HOSHIZAKI AMERICA, INC.

SERVICE BULLETIN

SB13-0012R1

SUBJECT: SA0143 / 4A1726-16 (RS64C2E-CAV) COMPRESSOR CHANGE

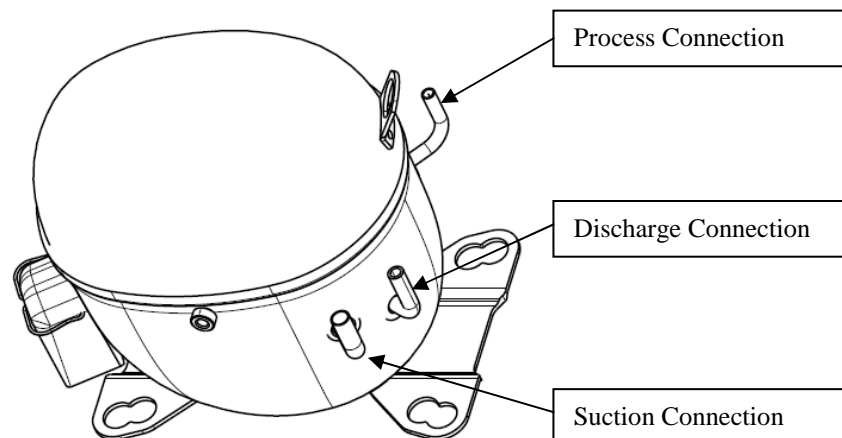
Although the footprint and the mounting of the compressors will be the same, this change may require connecting different size tubing. The tubing sizes are 1/4" I.D. for Process and Discharge and 3/8" for Suction. Use standard refrigeration practices to make the reduced connections. You may also have to lengthen the compressor leads during change over. See below for location of the ports on the replacement compressor.
